MAPLE STREET SHELTER
1580 Maple Street
Redwood City, CA
Project No. PC019

Issued on August 19, 2016

The following Addendum No. 3 to the above referenced project shall be included in the project Plans and Specifications.

1 Site, Phasing & Demolition Plan 1" = 20'

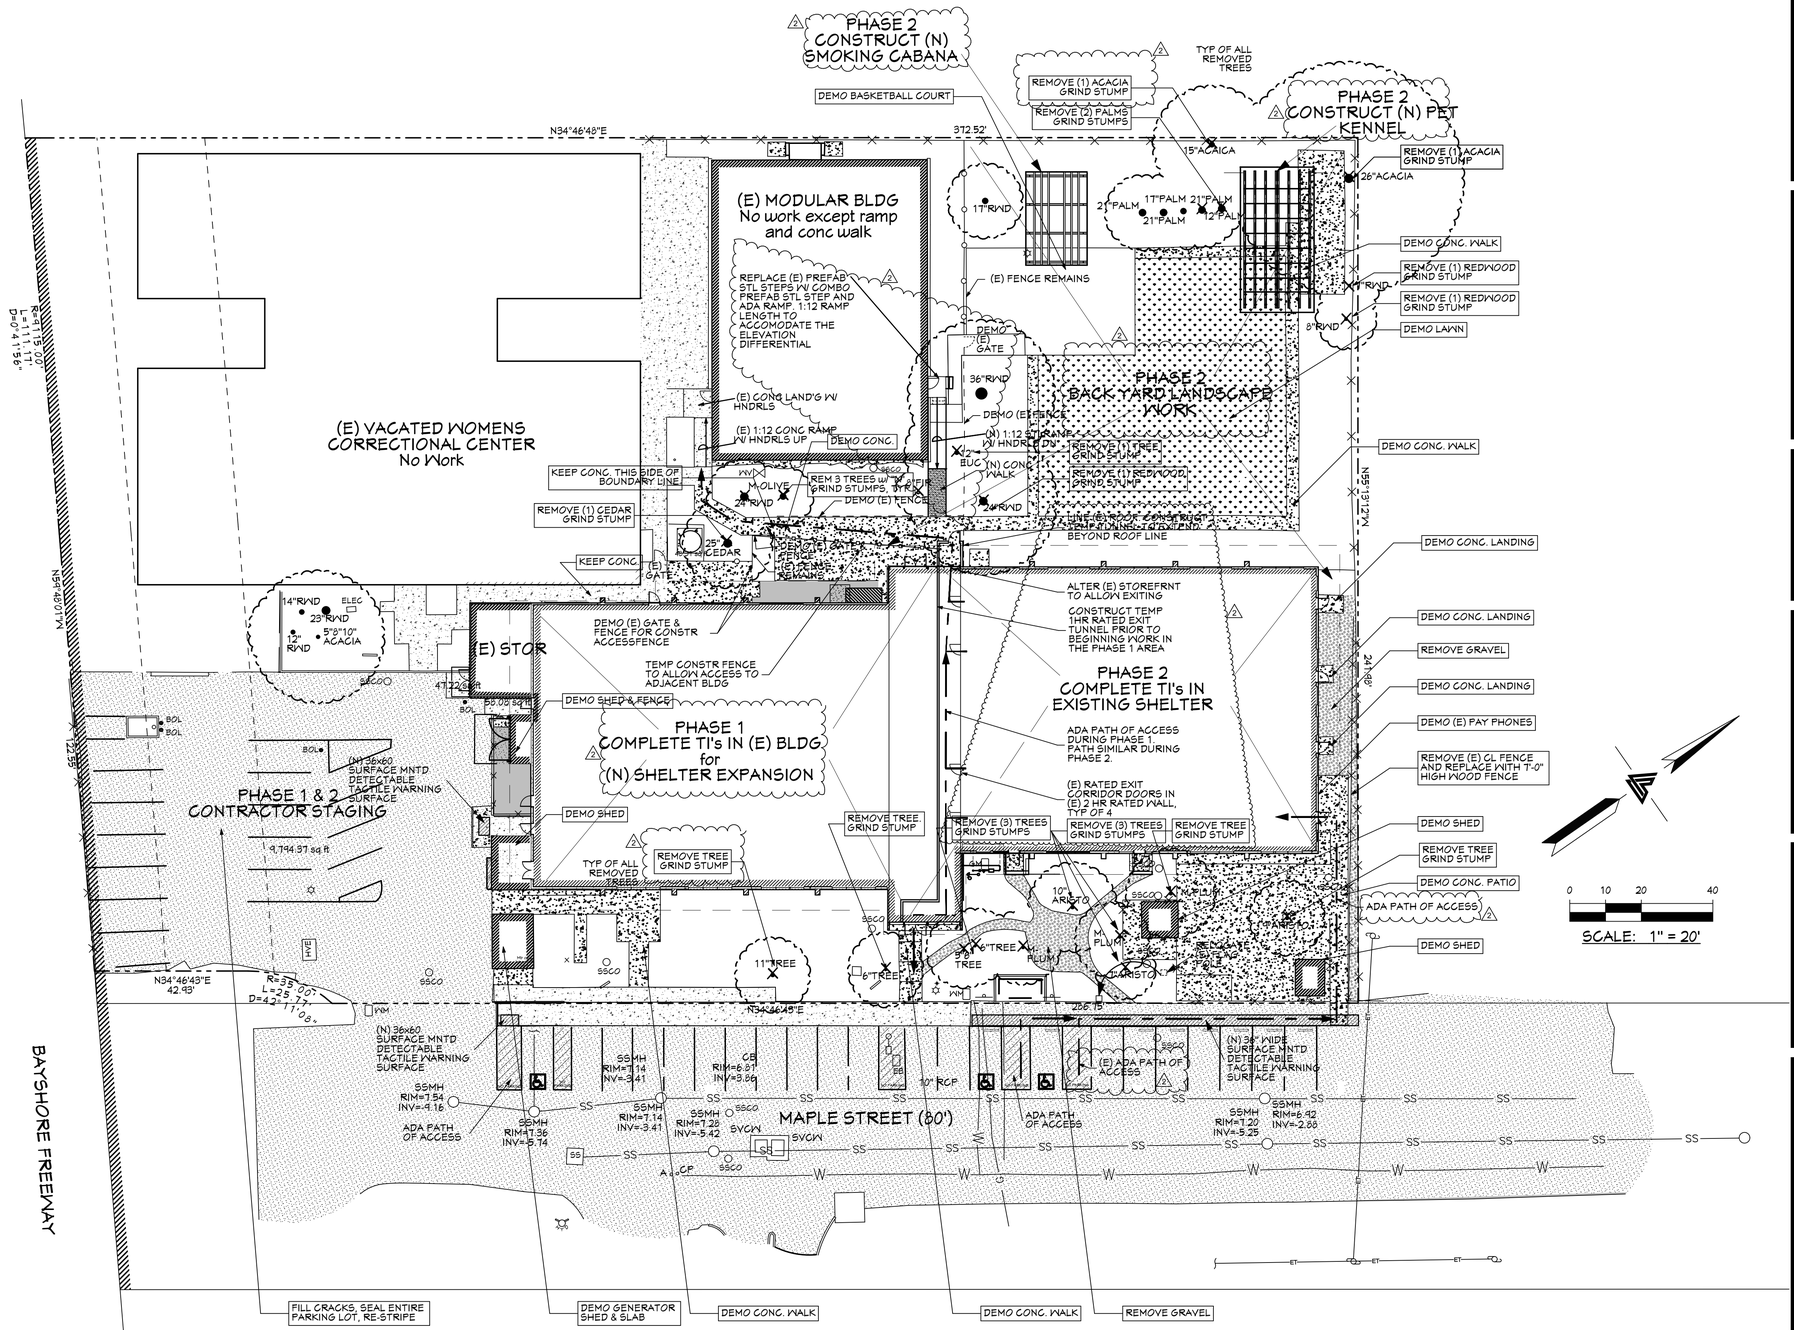
RESPONSE: Bid forms will be revised and issued as part of future Addendum #_4_
4. Q: Your plan Sheet A-1.2 indicates trees to be removed with words such as "Remove Acacia" (top right hand side of plan sheet. There are a number of other trees on this plan sheet which are also indicated to be removed with the words "Remove Tree" or "Remove Trees". There are other trees with an "x" through them which have no wording to indicate they are to be removed and the legend on the left side of the plan sheet has no mark for a tree with an "x" through it that indicates what this means. Can you please clarify whether trees marked with an "x" but otherwise have do not have any indication as to whether they are to be removed should be removed. Also, are the stumps to be removed for all trees that are removed?

RESPONSE : See revised sheet A1.2 with the trees to be removed shown with an "X" and an indication that the stump shall be ground out as well.
5. Q: it appears that the drawings are showing both wood studs A4.3, A4.4 and metal studs A7.5, S2.2, can you please clarify which stud material would be used for this project.

1 Wall Insulation & Curb Plan 1/8" = 1'-0"

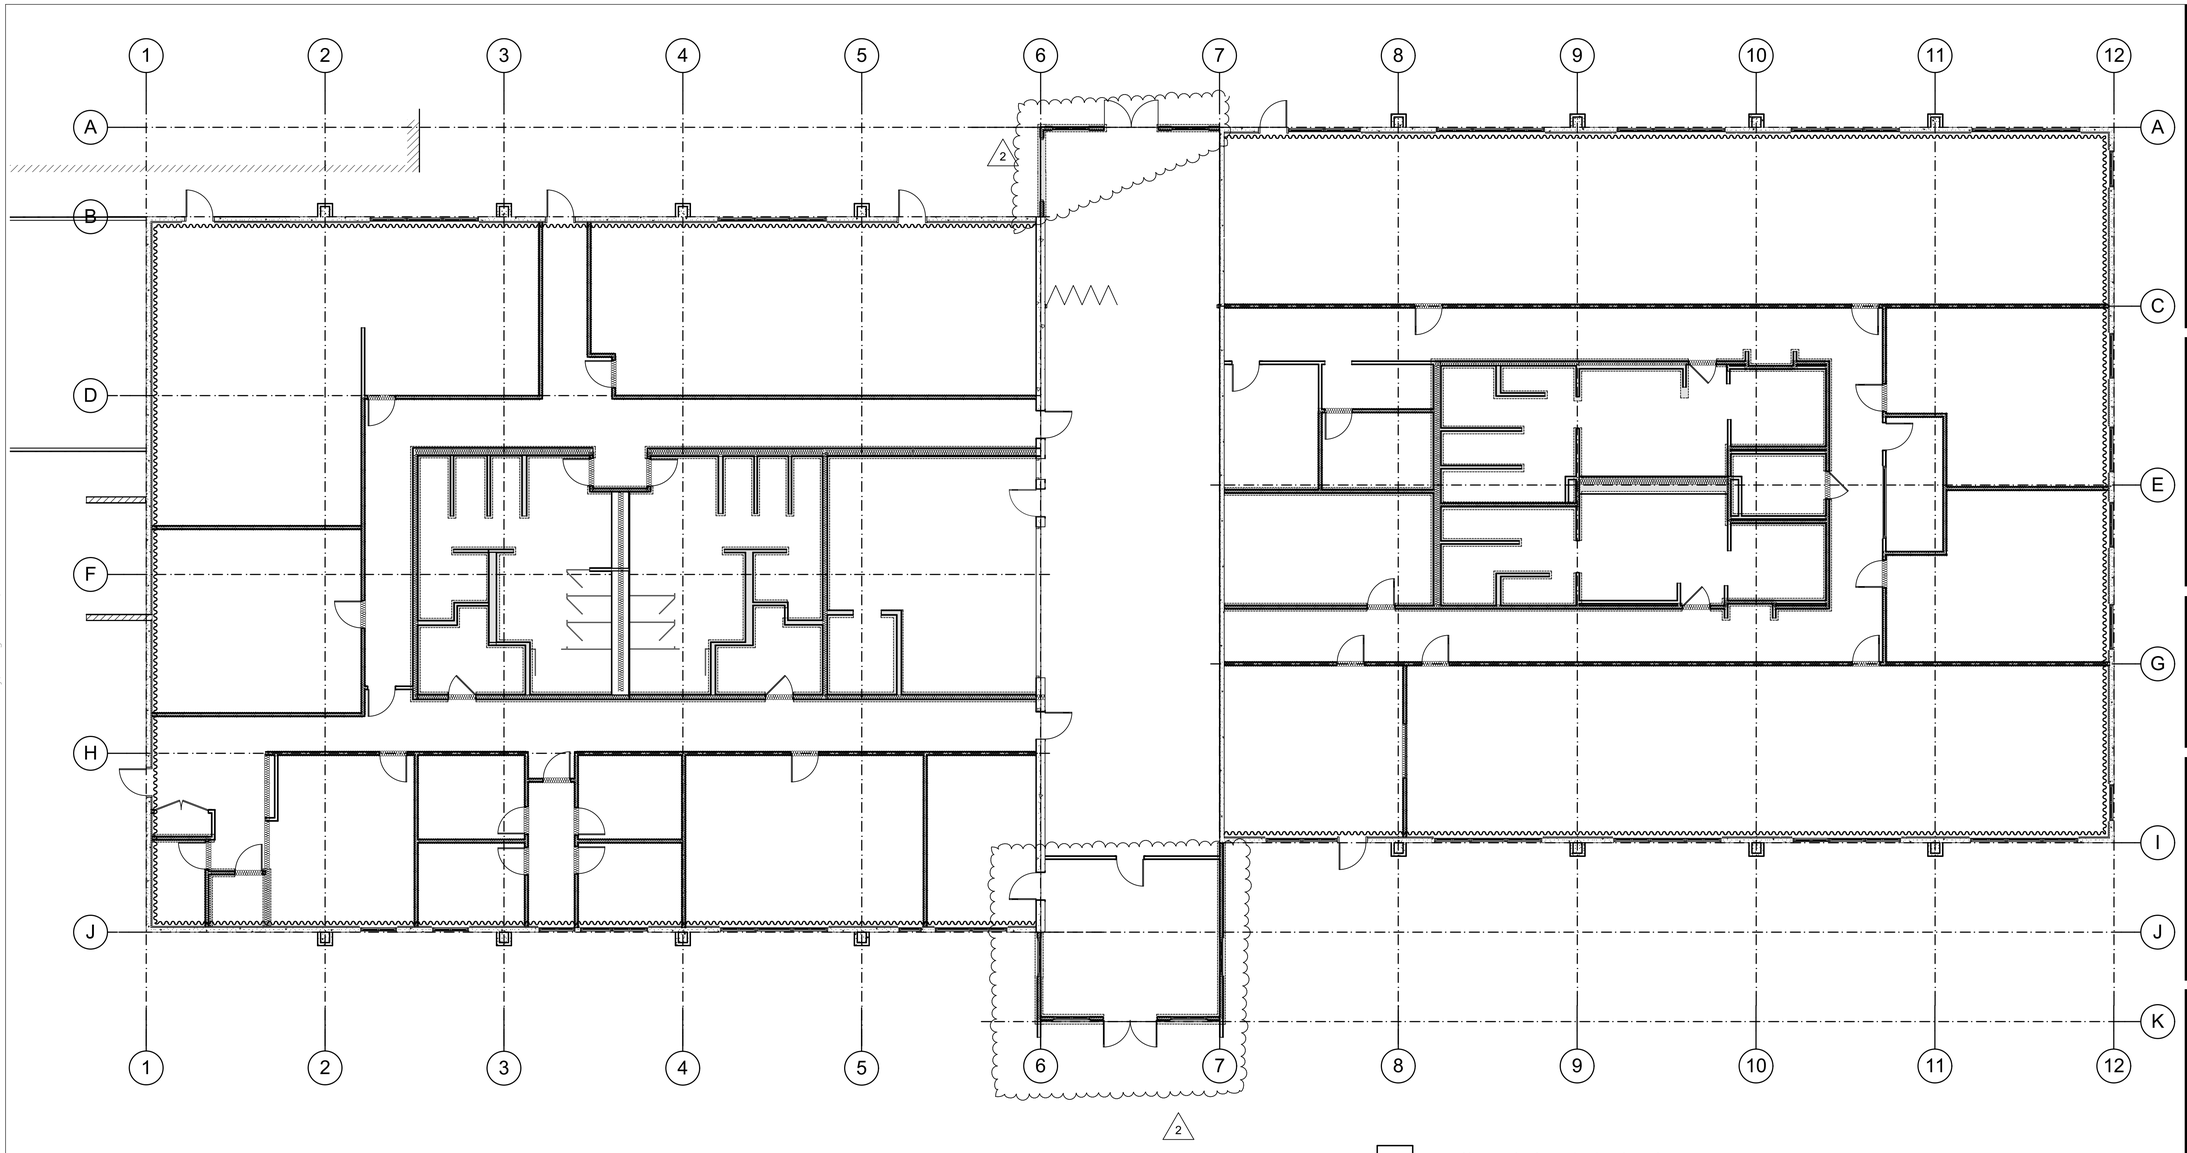
26. Q: Please define where concrete curbs are required and their dimensions.
RESPONSE: See Sheet A-2.8. Curbs are drawn diagrammatically. Curb with matches the stud wall width. N the case of the case walls the curb width is the width if the chase.
